Safety Defect and Noncompliance Report Guide for Vehicles
PART 573 Defect and Noncompliance Responsibility and Reports¹

On Dec 13th, 2013, Tiffin Motorhomes [MFR] decided that a defect which relates to motor vehicle safety exists in the motor vehicles listed below, and is furnishing notification to the National Highway Traffic Safety Administration in accordance with 49 CFR Part 573 Defect and Noncompliance Responsibility and Reports.

Heat Shield for 33AA

WI-228

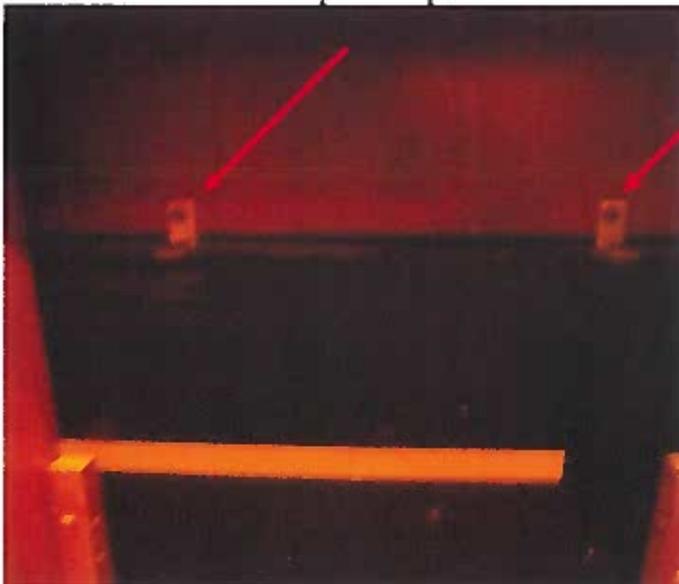
2. Disconnect power supply for fireplace. *See photo below*

3. Located inside bathroom remove two screws to remove panel and gain access to fireplace.
See photo below

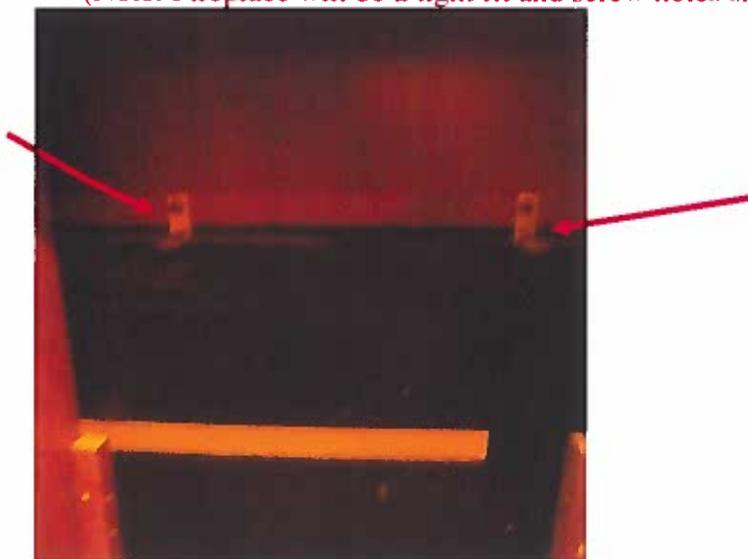
A. Connect power supply back for fireplace, *see pic below.*
